**Planning Application P140153: Partial amendment to Planning Application P130029
to allow for an additional 20 units and change of house types.**

Partial amendment to Planning Application Ref P130029 to allow for additional 20 units and change of house types - Application Number 140153

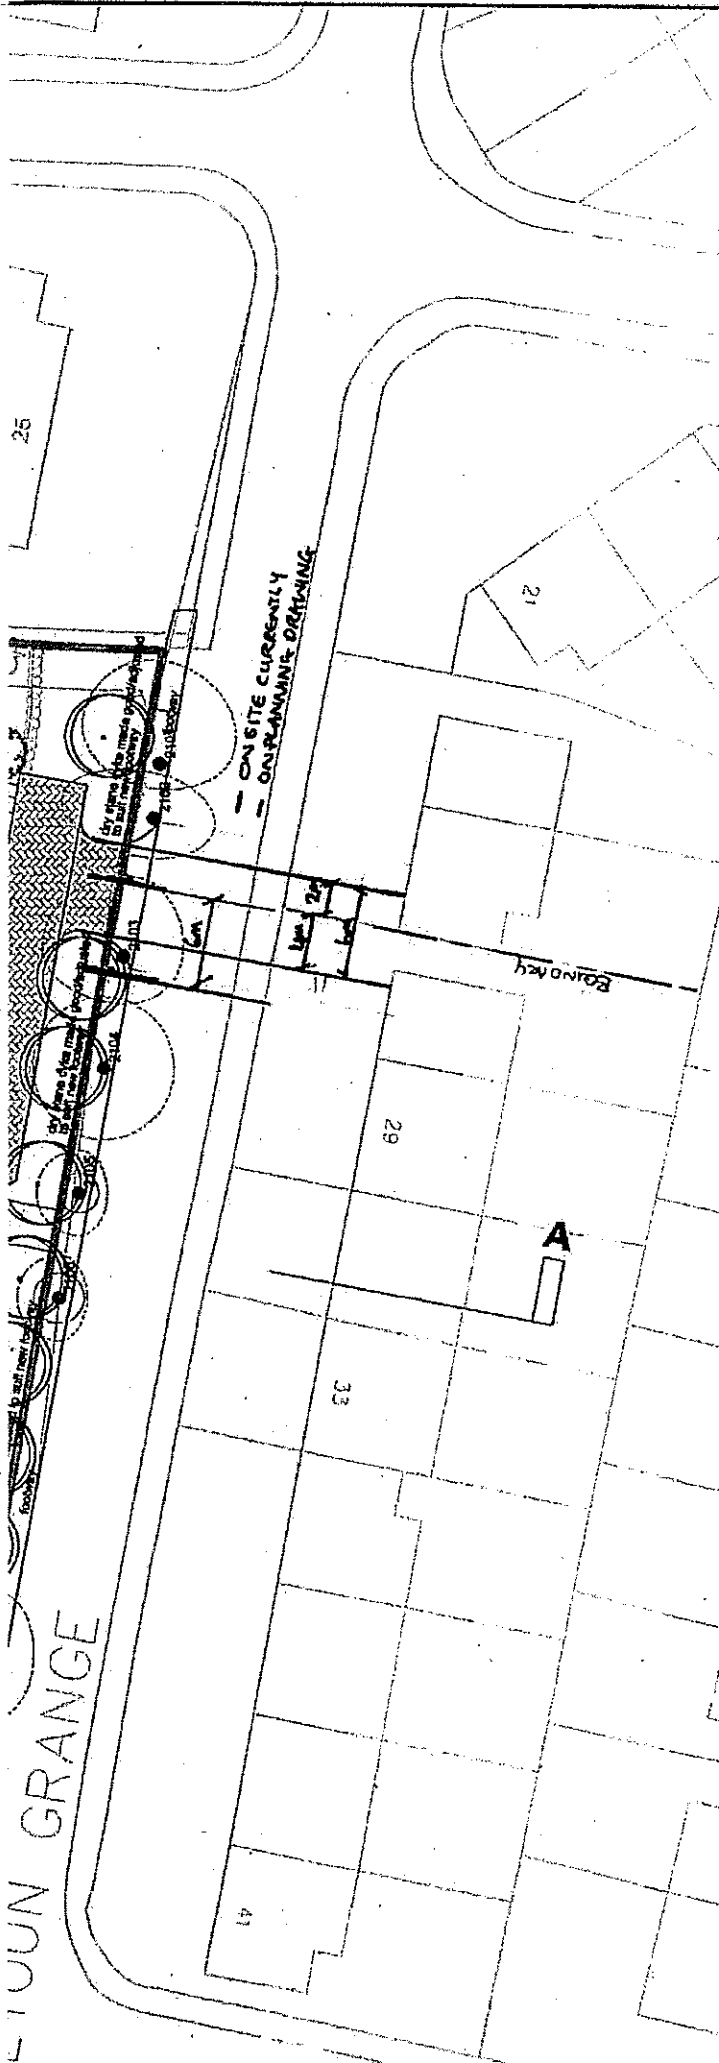
5. The rush to squeeze a further 20 units into the site has resulted in Plots 38-47 and 81-83 being shoe horned into the development. This type of 'pressure' planning has no place in today's urban development and flies in the face of the 'Designing Streets' guidance. This has unbalanced the scheme in terms of place and movement in respect of the 'heart' of the proposal and the entire North end of the development.

7. When comparing the proposed site layout of this application to the previously approved scheme, there are some significant anomalies, namely;
 - a) The footpath cycle link to the North of the site appears to connect to Hopcroft Drive through the garden of number 27 Hopcroft Drive with a new change to the ownership boundary.

- b) The 15m build line offset on the North of the site appears to now change direction a little to suit changes in the position of the affordable flats.

- c) The affordable units (Plots 30-37) have moved eastwardly and a change of this nature should see them and the surrounding area included within the red line application boundary, however this will further increase the density figures. As an aside I seriously question the positioning and location of the affordable flats, they are not in the correct location and should be positioned at the opposite side of the site, where the SUDS pond is located, car parking would be more accessible, footpaths links could be maintained and all units would have a more open outlook and a sense of place, not shoe horned into the corner of the site.

3. The application for partial amendment for an additional 20 houses would appear to move the whole layout of application 130029 at least 2m west on the whole site, when comparing the current approved plan and the application site layout. This moves the access road across from my property of 27 Hopetoun Grange, currently being used as a site entrance and exit 2m to the west from the currently approved plan (please see difference from approve plan compared to currently on site enclosed plan). As this access only has approval for vehicular entrance only, I find it highly dangerous when trying to reverse off my drive and there are HGV lorry's driving out of this entrance only. As this entrance seems to have moved position, it would seem that this area should also be taken into consideration when looking at this application at added to the red line boundary.

4. Looking at the current approved plan and the application site layout, the affordable units at the very North of the site have been relocated to the West, therefore these units should be taken into the red line boundary for the application of 140153.
5. Has consideration been given in relation to the 2020 57dB noise contour and how this will affect the development? With completion of some of these units into 2015-2016 potentially, I think that designing for the future and not the past of the 2006 or 2011 noise contour is incredibly important.
